Our Ref: 239971  
Council Ref: DA/2022/00538

**RE: DA/2022/00538 - COMMERCIAL PREMISES & SHOP TOP HOUSING DEVELOPMENT  
LOT 1 DP 1166015 - 643 HUNTER STREET, NEWCASTLE WEST**

Please accept this submission as our formal response to the further comments provided by City of Newcastle's internal referral responses to DA2022/00538 via email on the 14<sup>th</sup> September 2022.

PROJECT	DRAWING TITLE	PROJECT No.	DRAWING No.	AMDT
WATERVUE 643-651 HUNTER STREET NEWCASTLE	POST-DEVELOPMENT PMF STORAGE DEPTHS	7330-01	041	1

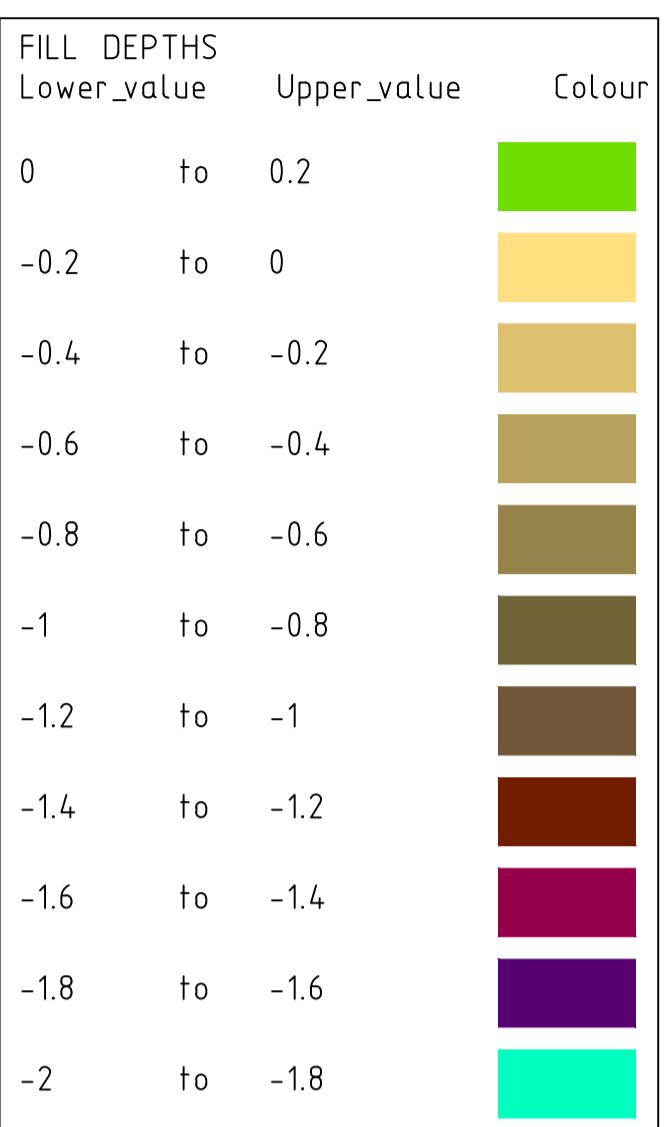
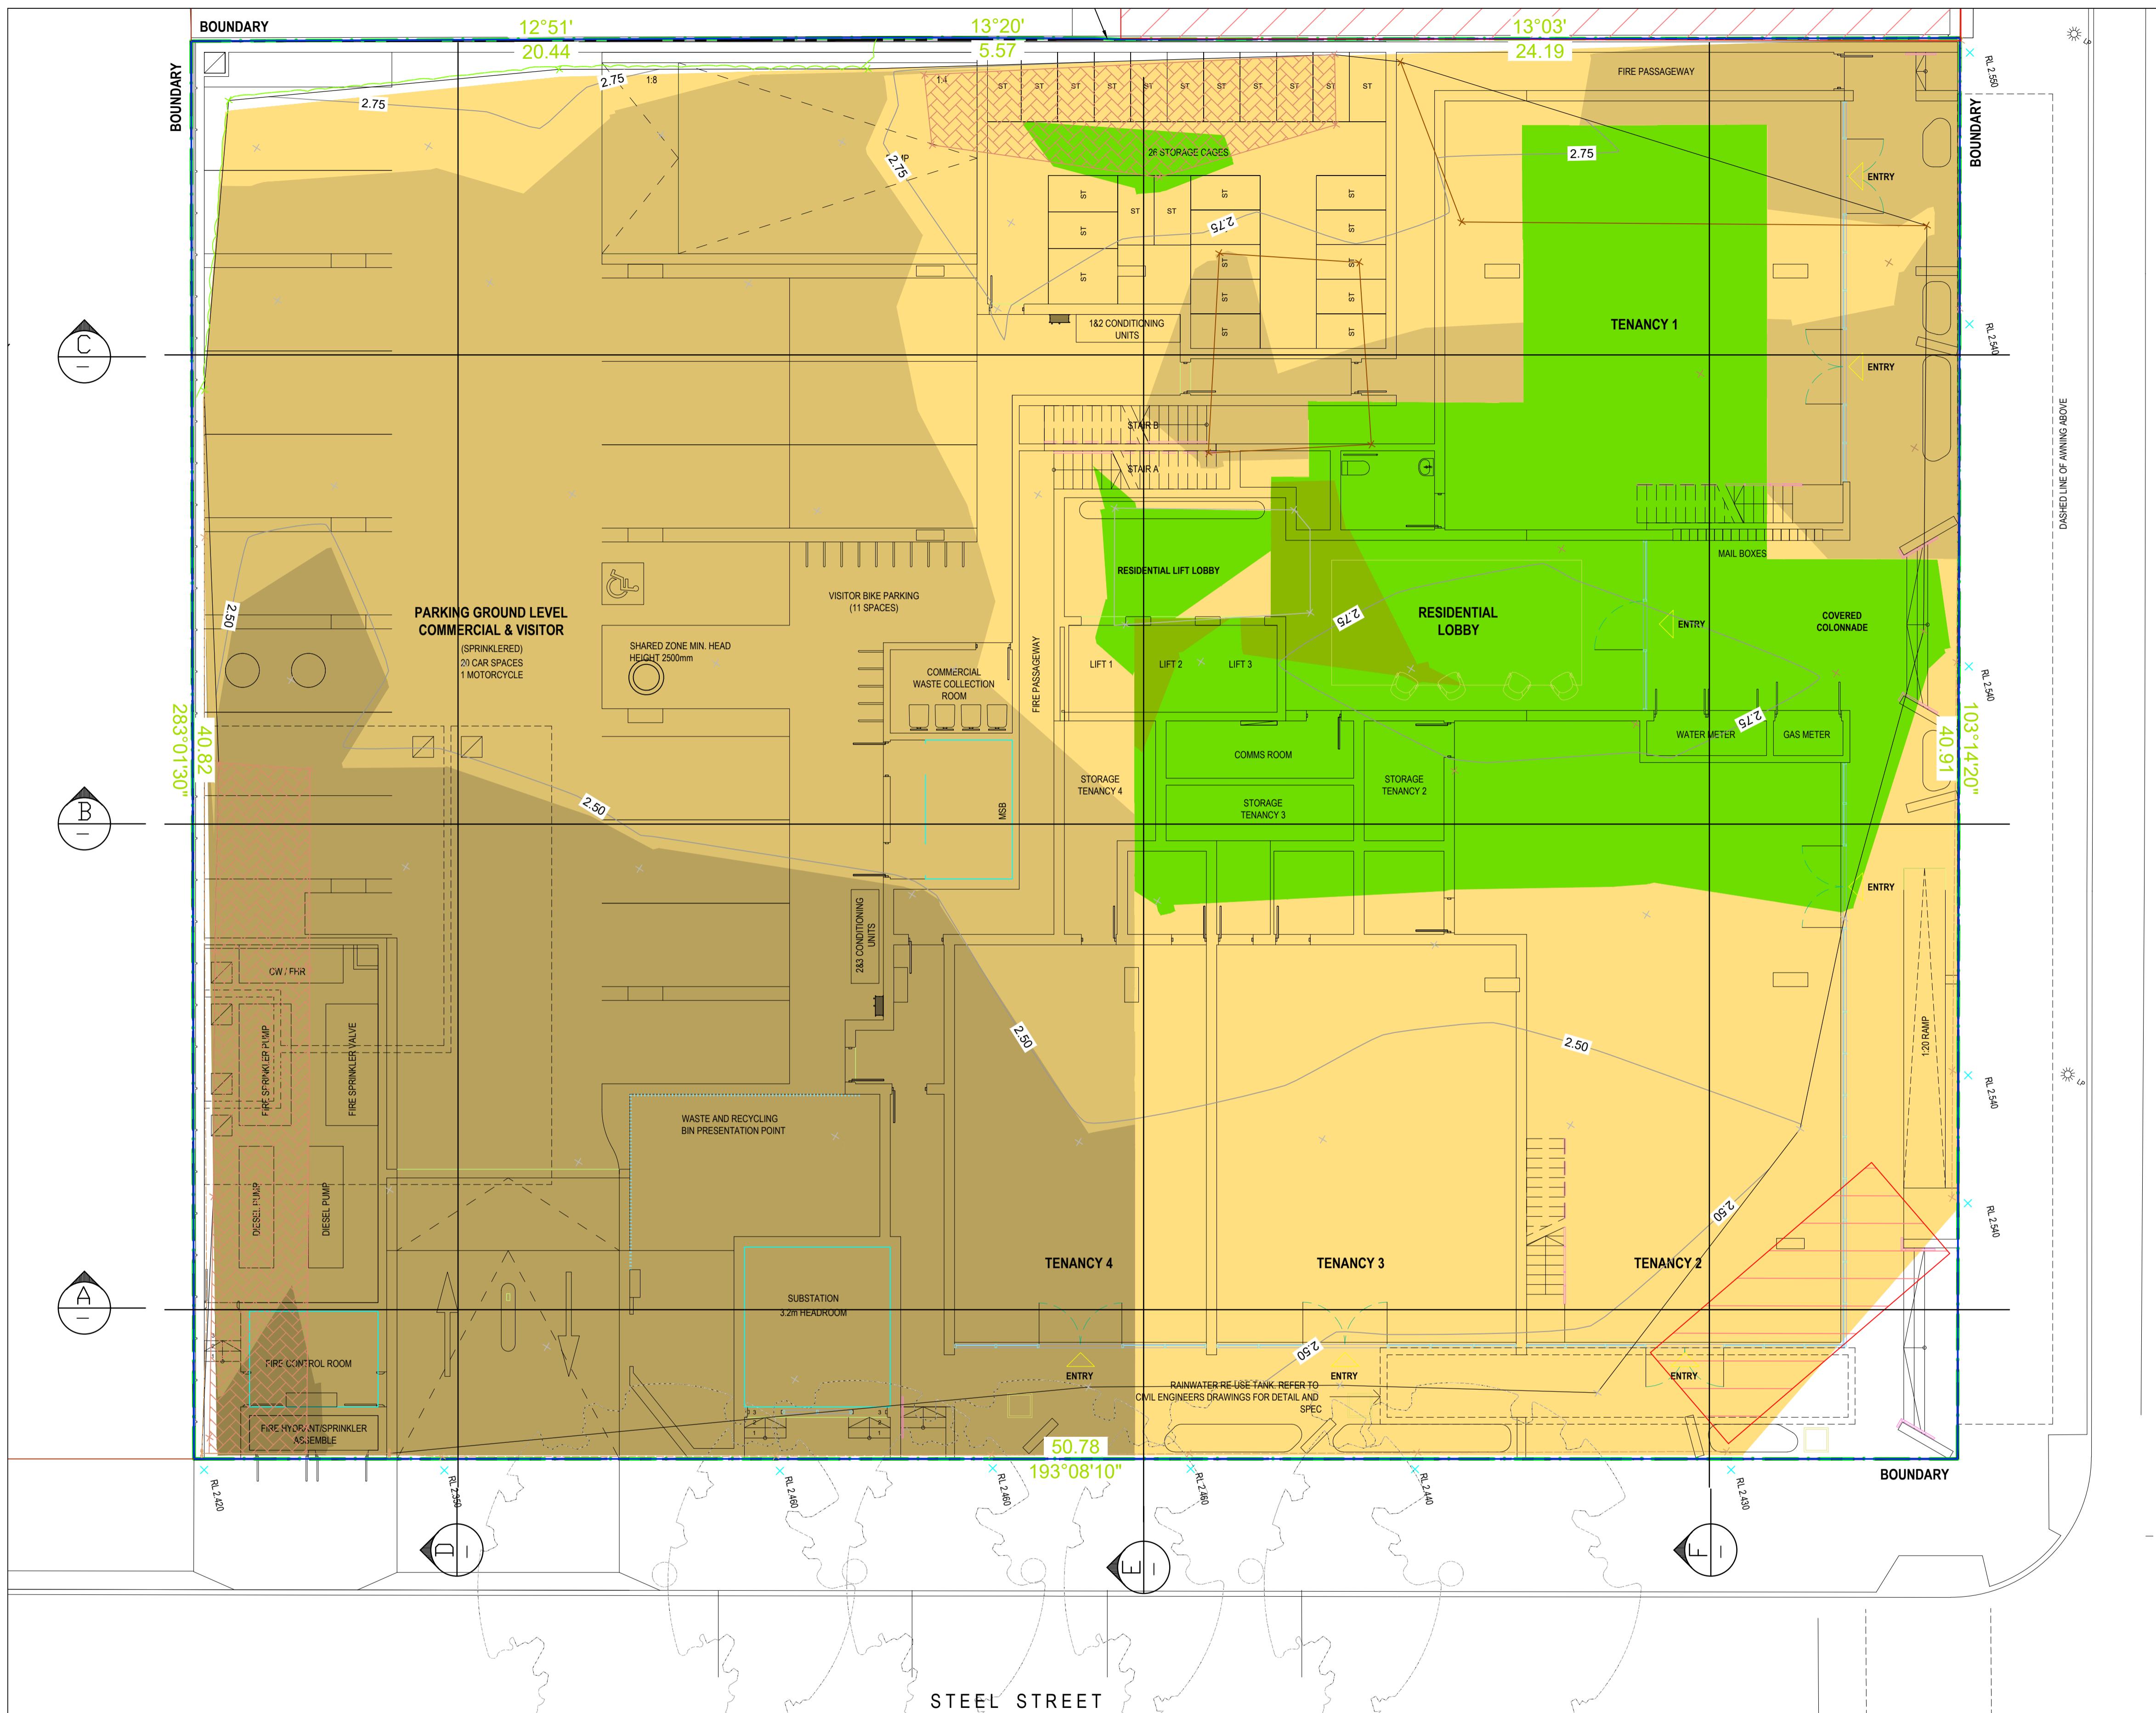
2.2 Flood Storage – Council Comment	Response
The development does not address NDCP requirements for flood storage preservation. The submitted SEE acknowledges "the subject site is identified as a Flood Control Lot" but erroneously states that "the site is not affected by a floodway or a flood storage area."	As a requirement of Section 4.01 of the Newcastle Development Control Plan (NDCP), any development on the site shall not fill more than 20% of the allotment area. Cut and fill plans have been submitted showing that the site will not reduce the total storage available in the PMF event by more than 20%.
Calculations are to be included for natural and post-development flood storage volumes within the site during the Probable Maximum Flood event. Displacement exceeding 20% of the natural storage volume over the site may be addressed through the provision of compensatory on-site storage.	Calculations have been provided on the PMF Storage drawings (Refer to 7330-01-040/041).

PROJECT No.	DRAWING No.	AMDT
7330-01	047	1

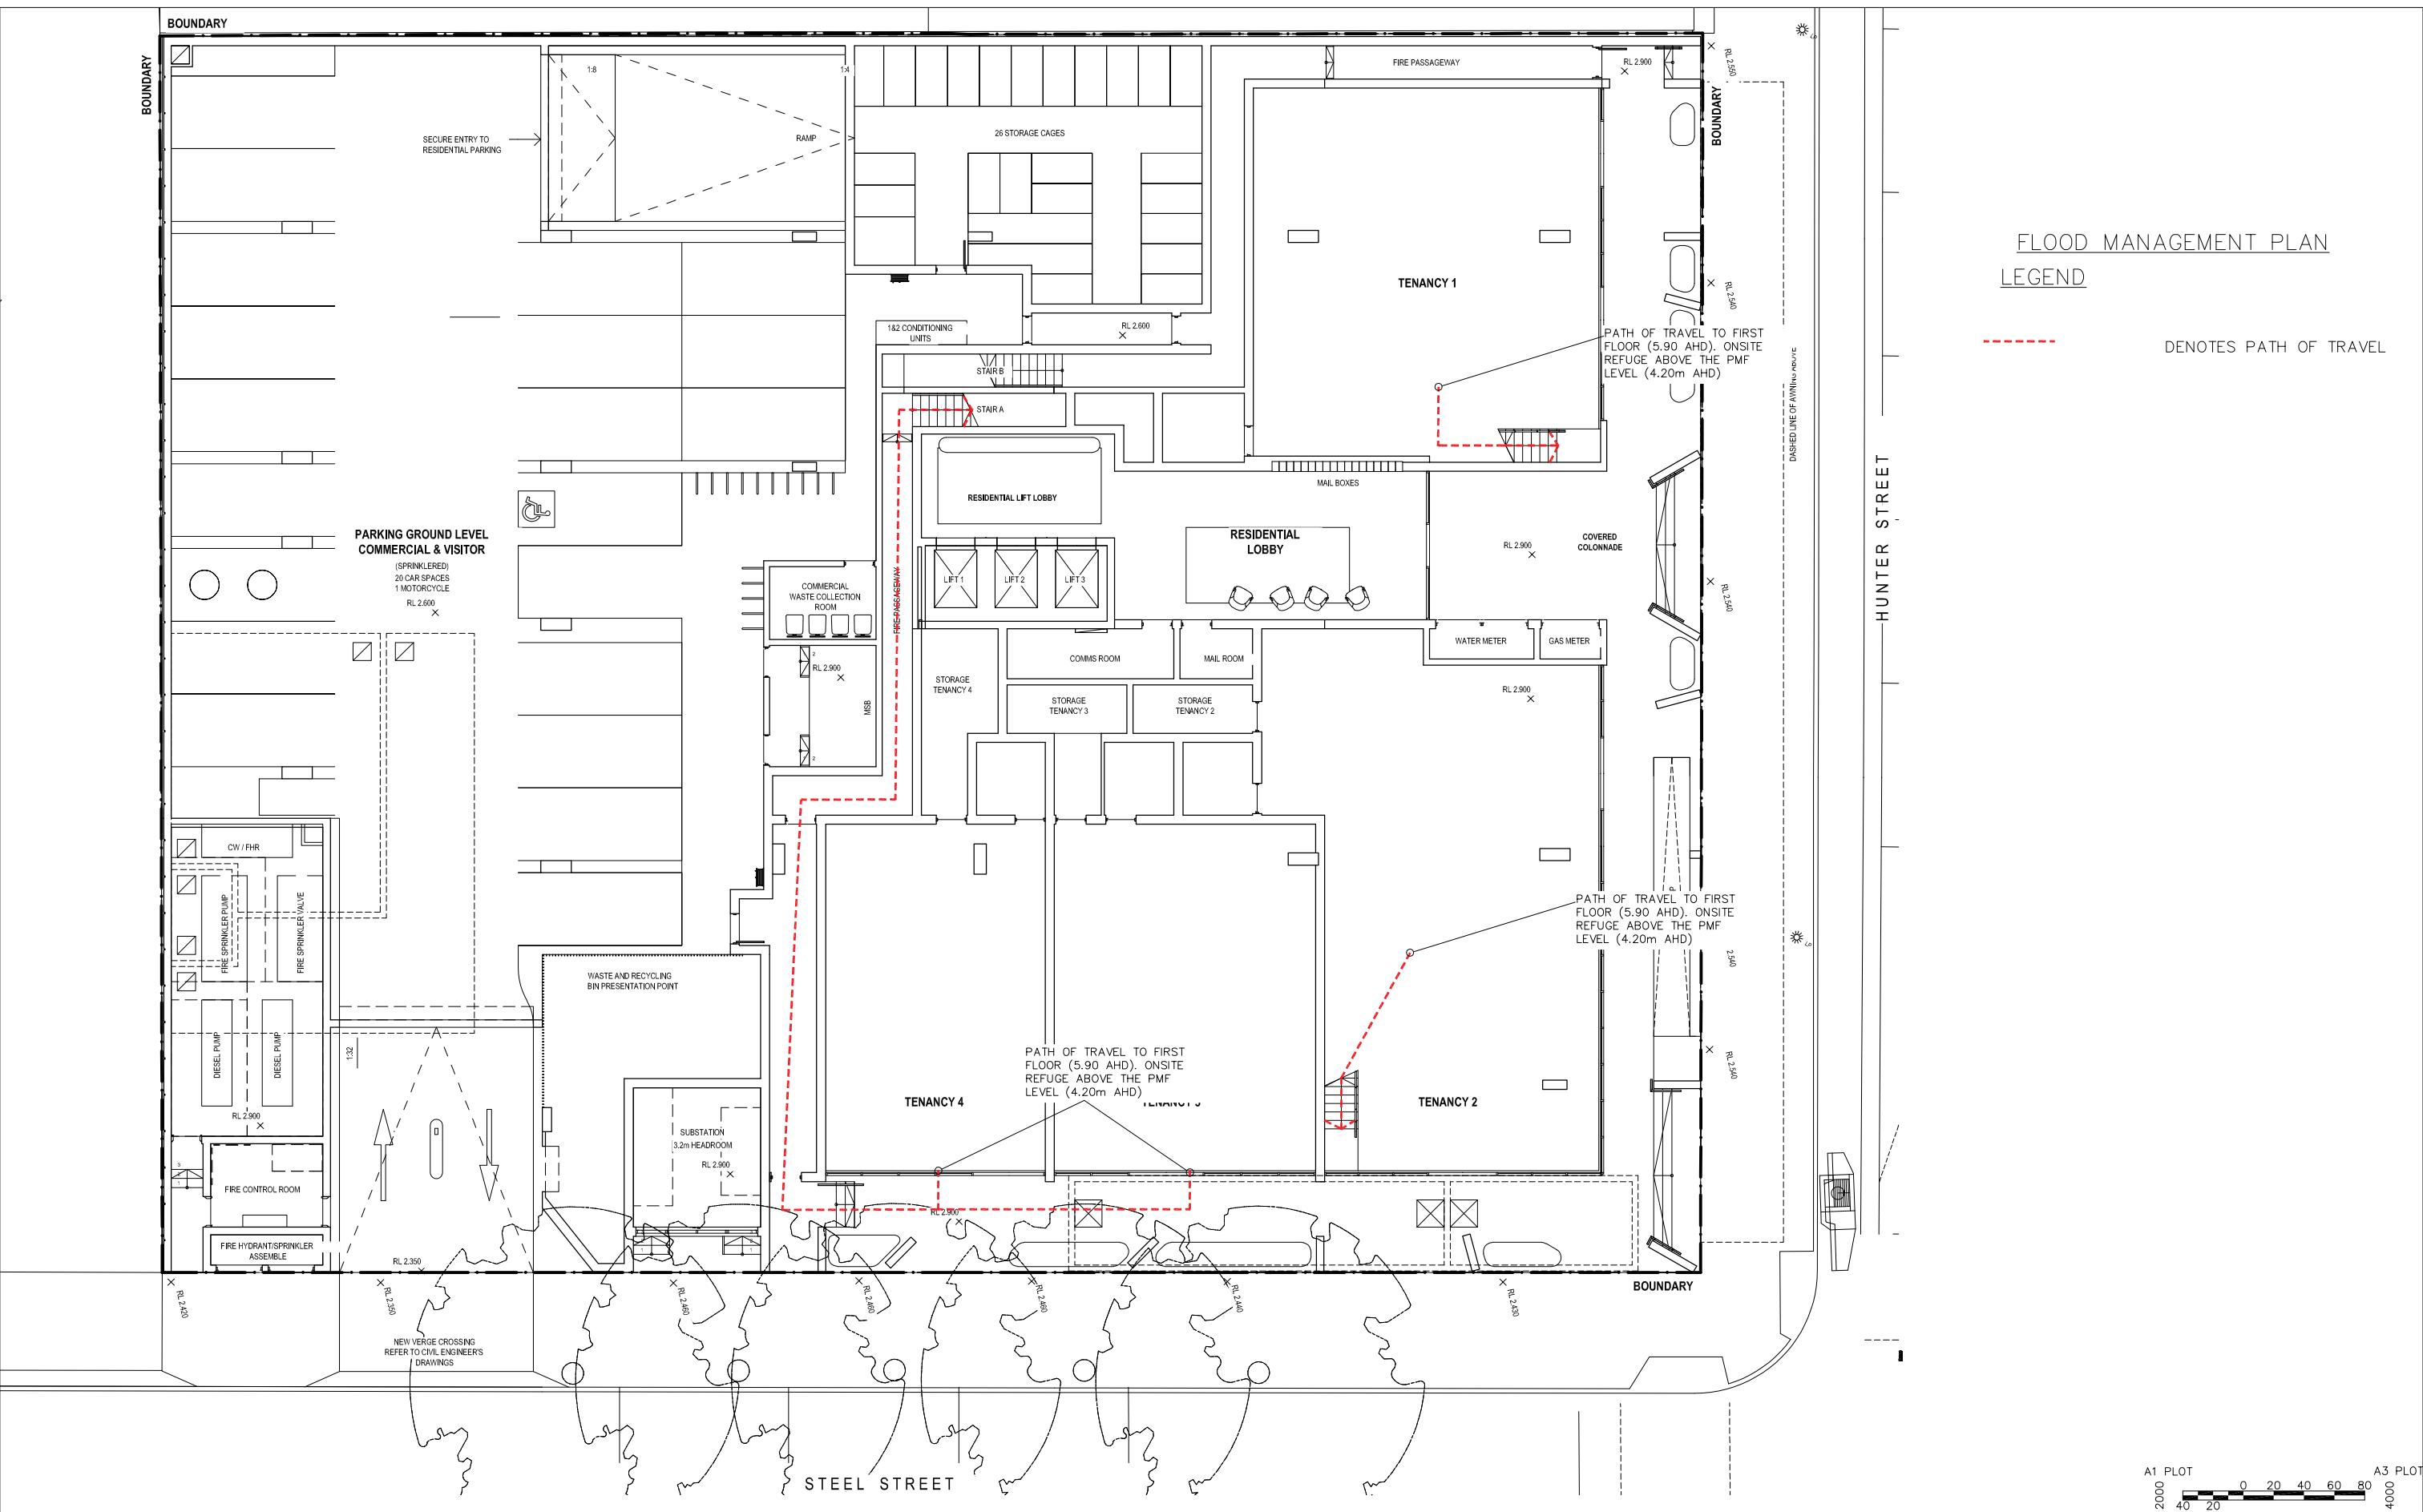
2.1 NDCP 2012 - Council Comment	Response
reasonably expected on the development site and be provided with emergency lighting.	<p>Refer to <b>7330-01-047 flood evacuation ground floor</b> which shows the path of travel for refuge during PMF.</p> <p>The first floor, being situated at 5.90m AHD, is suitable for on-site flood refuge during the PMF (4.20m AHD) provided the structure is designed and constructed to withstand hydraulic forces generated during such an event.</p>

2.3 Flood Evacuation Routes – Council Comment	Response
<p>Building occupants in the ground floor commercial tenancies and residential lobby must be provided with a self-evident route to on-site refuge elevated no lower than 4.20m AHD. The Applicant is requested to provide a brief outline of refuges available to each tenancy and indicate the route of evacuation to these refuges on development plans.</p> <p>To facilitate access to the proposed commercial waste collection room, and also shorten evacuation routes, the Applicant may consider the provision of pedestrian access direct from each commercial tenancy to adjoining fire passageways.</p>	Flood Evacuation path of travel has been indicated on plans. Refuge from PMF is accessible for each commercial tenant and path of travel is shown on plans (refer to drawing 7330-01-047).
